# Roebuck Residents' Association

**SHD: Our Lady's Grove, Goatstown Road ABP 309430-21**

**Developer: Colbeam Limited**

02/03/21

## 2.5 Future Needs of the Schools

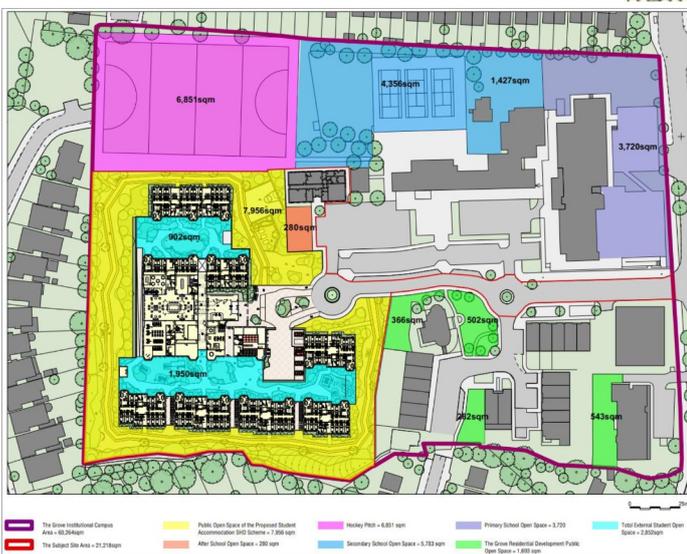
- The reduced area of the OLG Primary/Secondary is 2.30ha compared with Department of Education standard of 4.17ha. It is essential that the pupils of the schools have usable access to available Public Open Space on site.

- The Colbeam application has again ignored this section of the CDP and has made no provision for school facilities behind the school to the North West of the site.

- The only area of open space of any significance (over the attenuation pond) is clearly shown as Student space and no play/amenities have been provided suitable for the pupils.

Colbeam Limited Application

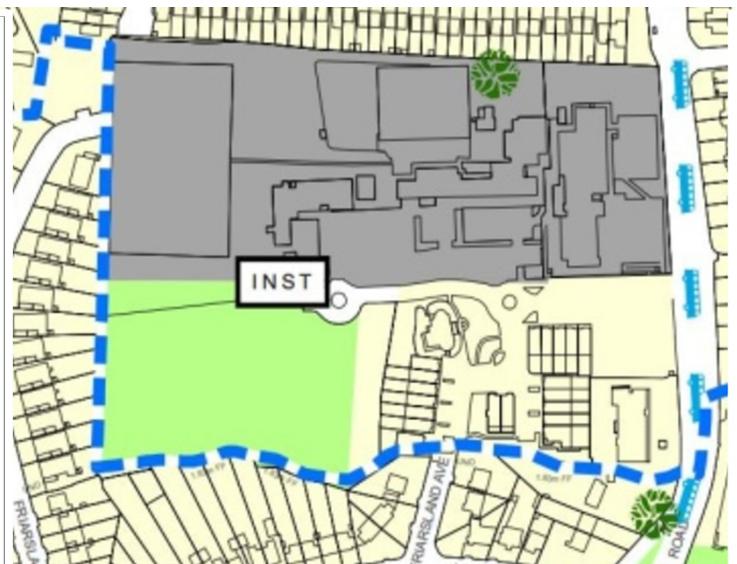
- The grey area on the CDP map is a new SNI (Sustainable Neighbourhood Infrastructure) Zone where housing is not a permitted use.
- The Colbeam Limited Application has the North Block, and approx 75% of the Middle Block, in this grey area. An area that the DLR Executive proposed as a SNI zone in the Draft CDP. The proposed development is also to be built on the tree line, requiring removal of all the trees.
